# 301 NE NORTHGATE WAY

CITY OF SEATTLE DESIGN REVIEW

DESIGN RECOMMENDATION REVIEW  
DPD PROJECT # 3018742  
SEPTEMBER 28, 2015

Pedestrian Connectivity & Safety.

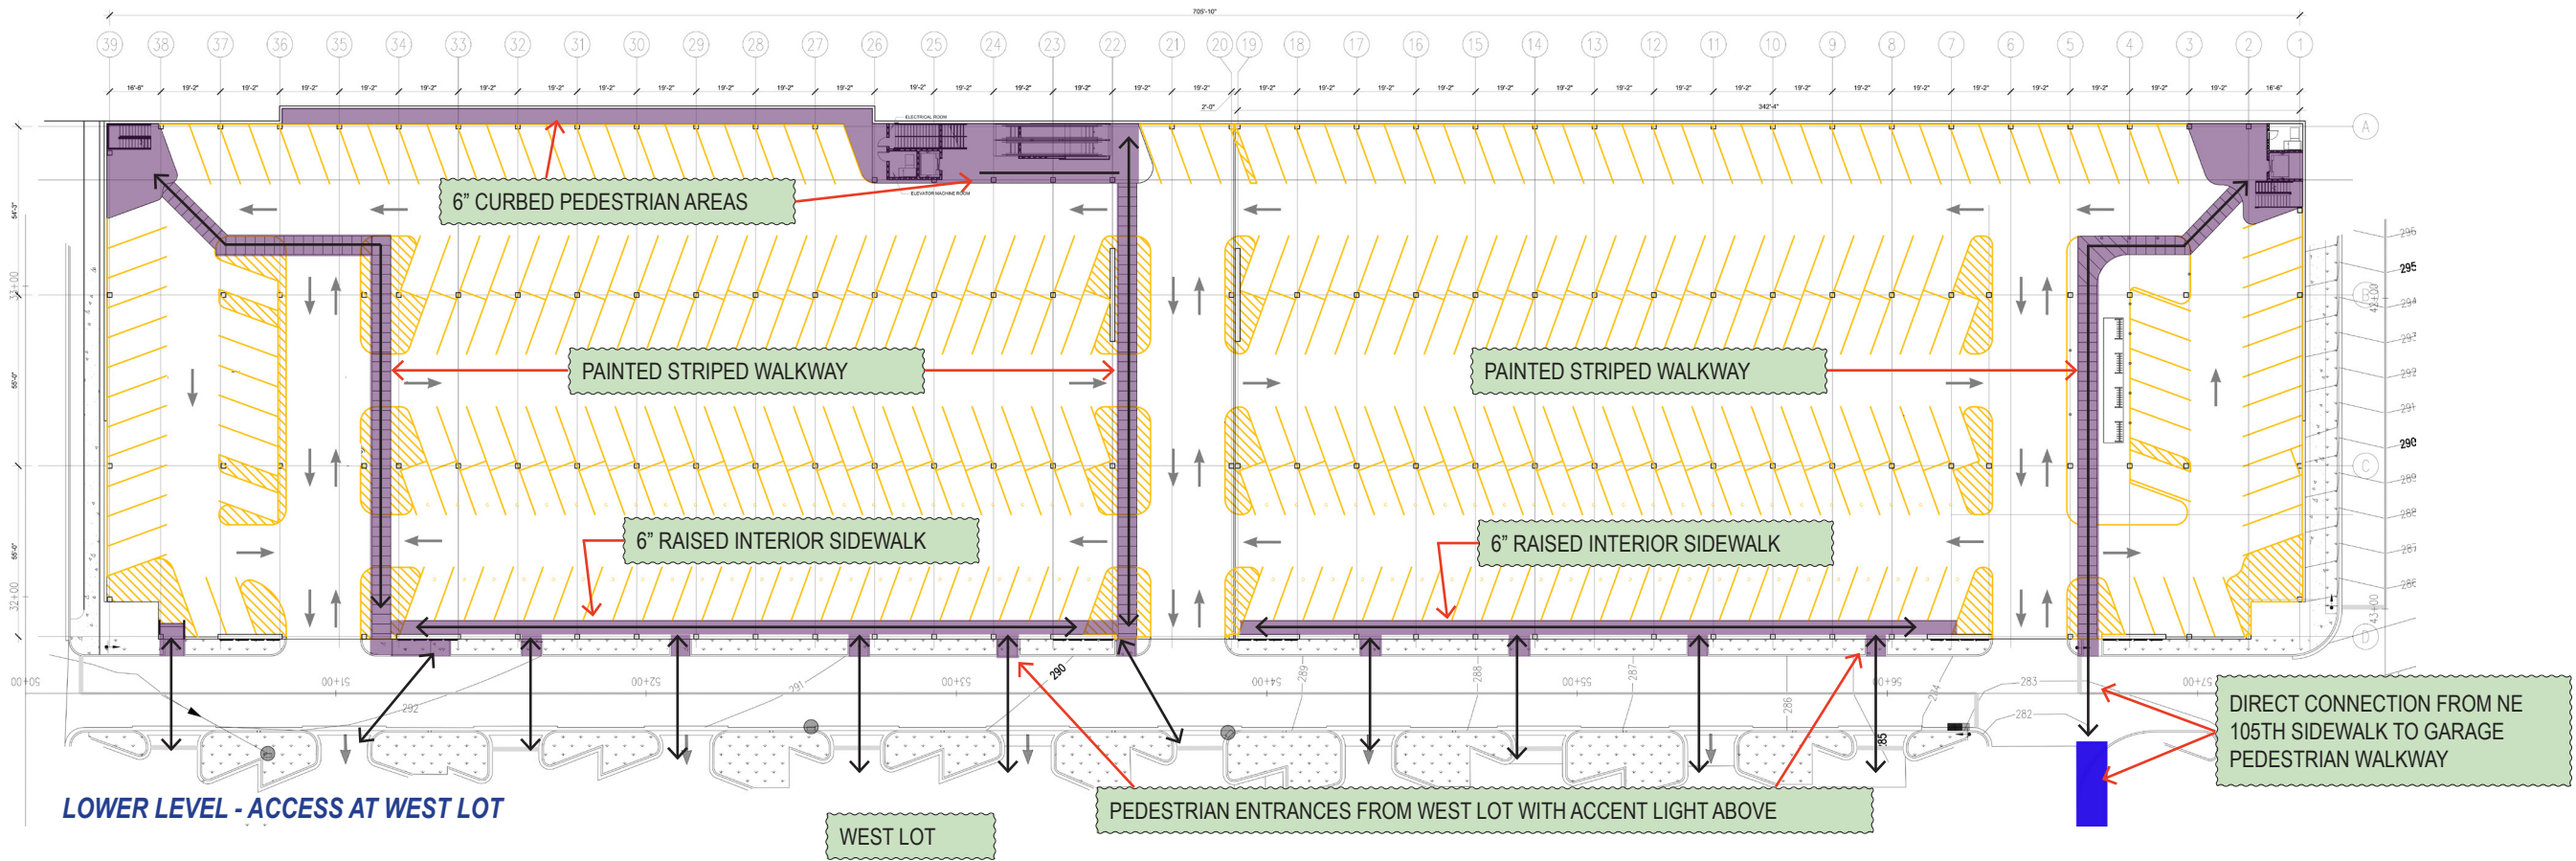
The Board emphasized the importance of pedestrian safety and the need to minimize vehicle-pedestrian conflicts. For the next meeting, the Board requested additional information on vehicle and pedestrian circulation. The applicant should study proposed pedestrian and vehicle circulation patterns and provide additional information on the proposed traffic flows and pedestrian pathways and crossings (including pedestrian connections from 1st Ave NE and the future light rail platform and plaza). (PL1-B, PL1-II, PL2-III-vii, DC1-B, & DC1-IV-i)

Pedestrian circulation patterns for the project site and the entire mall campus have been provided on the diagrams on pages 12-13. Vehicular and pedestrian interactions can be seen from the plan diagrams below. A sidewalk has been added on the west edge of the small JCP lot being reconfigured as part of this project, to provide a secondary connection to the Light Rail Station. The primary connection is through the mall to the south mall entrance down to the southern mall sidewalk that leads to the future Sound Transit station. The specific connection between the Light Rail Station and the mall sidewalk is being provided by Sound Transit, including a curb ramp at the southwest corner of the existing mall sidewalk. Please refer to the Sound Transit design documents for this connection.

Additionally, the lower level has been revised to incorporate an interior colonnade sidewalk along the western edge so that pedestrians entering this level from the adjacent west lot may safely walk to the designated east-west directional pedestrian walkways and avoid walking through the drive aisles. A pedestrian entrance has also been provided at each end of the west lot drive aisles. These are marked with an accent light from above so that users can easily identify these entrances. The main pedestrian entrances are located directly adjacent to the vehicle entrances, within the Greenscreen frame so that they are easily identifiable. The east-west direction pedestrian walkways are striped the entire length to promote driver awareness in these areas. The lower level will be well-lit throughout. The plan diagrams below for both levels show these different pedestrian pathways.

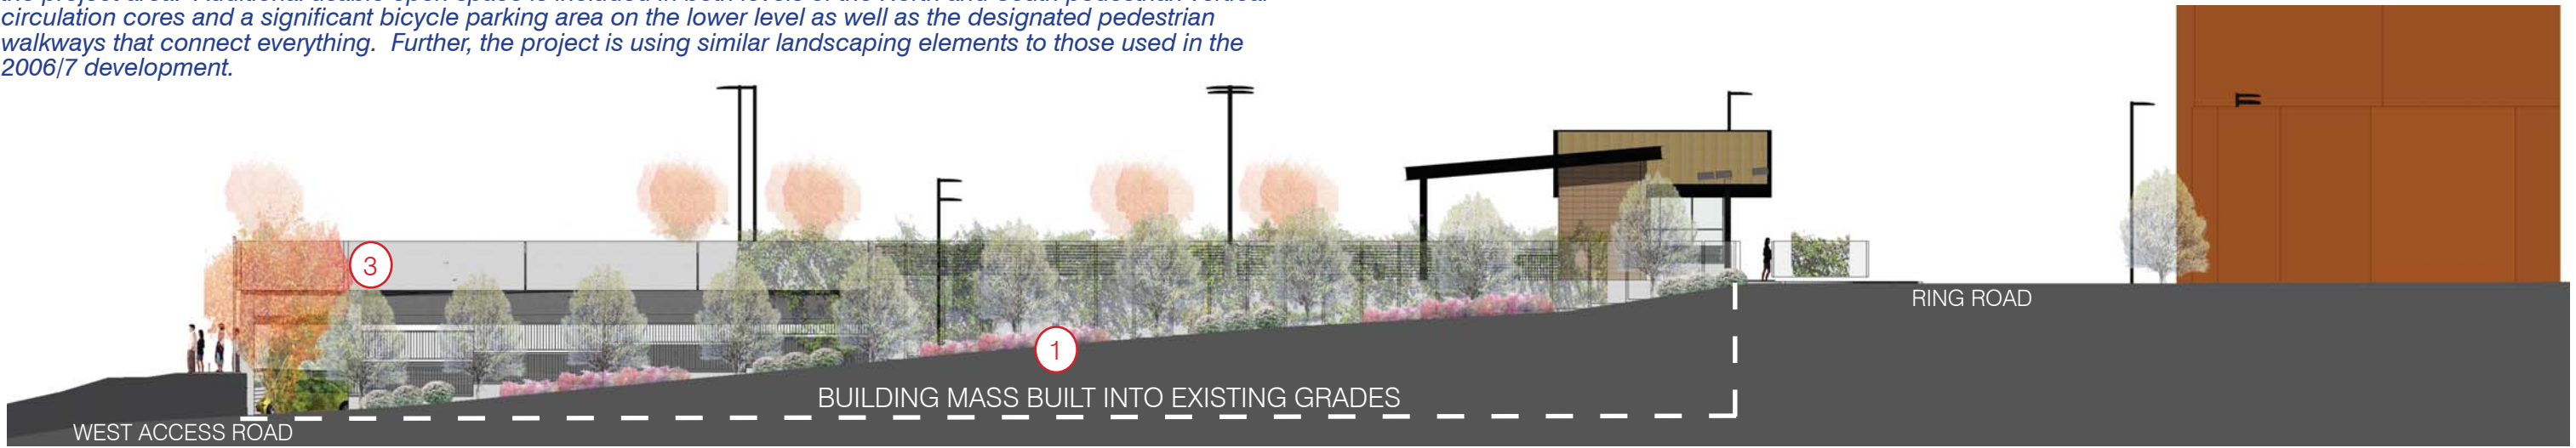
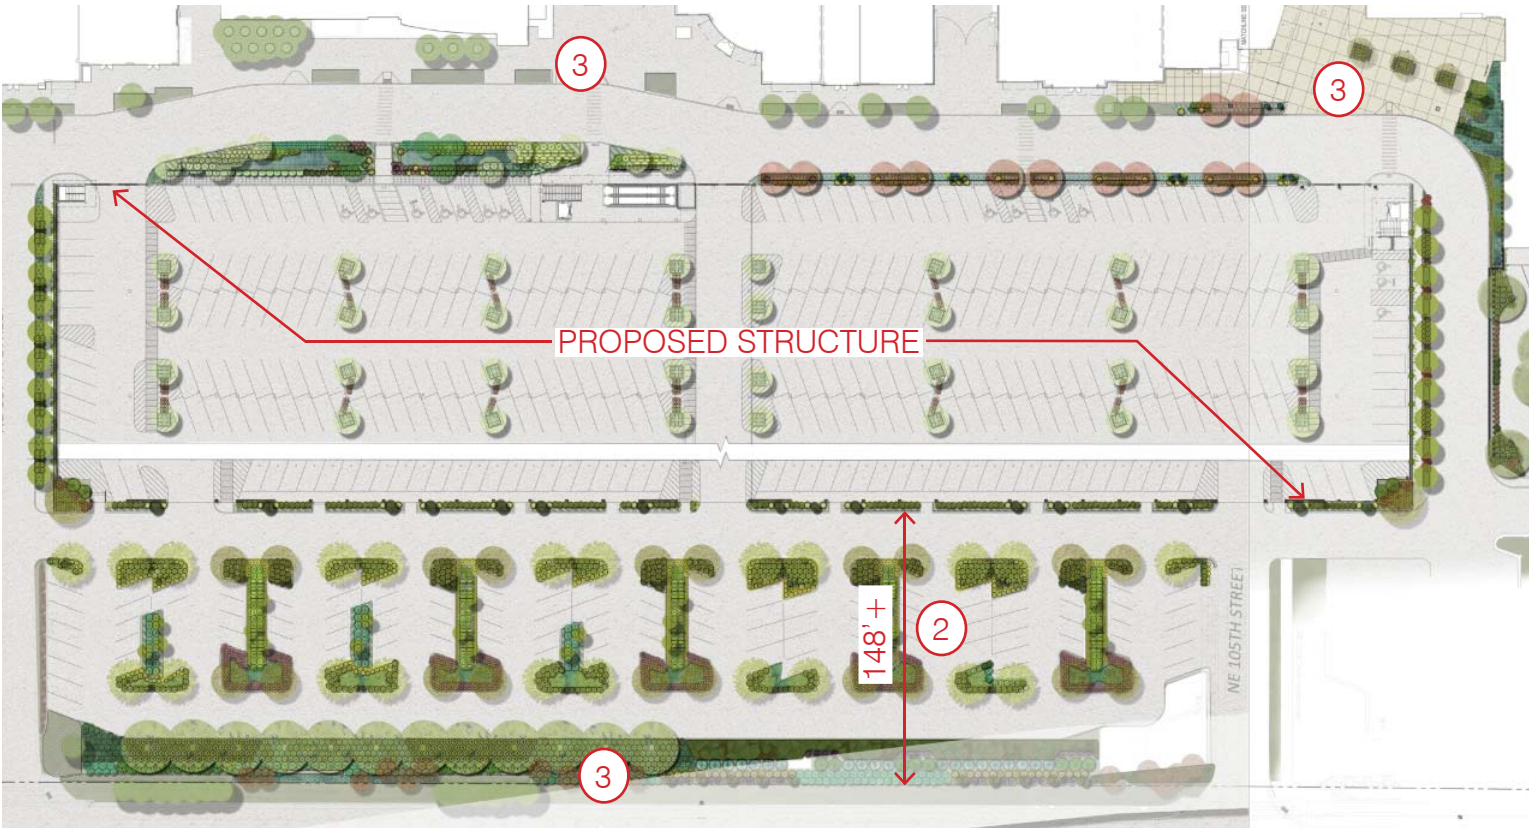
b. Site Context.  
For the Recommendation meeting, the Board directed the applicant to provide additional information on the site and surrounding context (from approximately NE 107th St and NE 103rd St and 1st Ave NE and 3rd Ave NE) including plans, graphics, perspectives, and renderings. Supplemental graphic information should include the adjacent future Sound Transit Station and associated improvements in order to better understand the site context and relationship to the station. Specifically, the Board requested perspectives from I-5 looking towards the proposal and perspectives that included the light rail platform and pylons. Additionally, the applicant should provide a current phasing plan and post-light rail construction site plan that shows final build out of the transit project, pedestrian in-frastructure, surface parking, and parking structures. (CS2-B & PL4-C-1&3)

Response:  
Plans, graphics, perspectives, and renderings as requested and as applicable for the site and surrounding context have been included. The Sound Transit work is currently not shown since they have not yet completed their design. As can be seen from pages #2 / 33 and site elevations, the proposed structure has minimal mass, blends into the existing topography, does not limit the view, and is hidden mostly by adjacent landscaping. Since the future Sound Transit guideway will be in front of this proposed structure from the I-5 perspective, much of this proposed parking structure will be further hidden when the Sound Transit project is complete. The diagram on page 48 shows the phasing of when different portions of the parking area and Sound Transit site will be under construction. Sound transit has not shared drawings that can be used for perspective renderings and since their design is not complete, it would reflect an incorrect project.
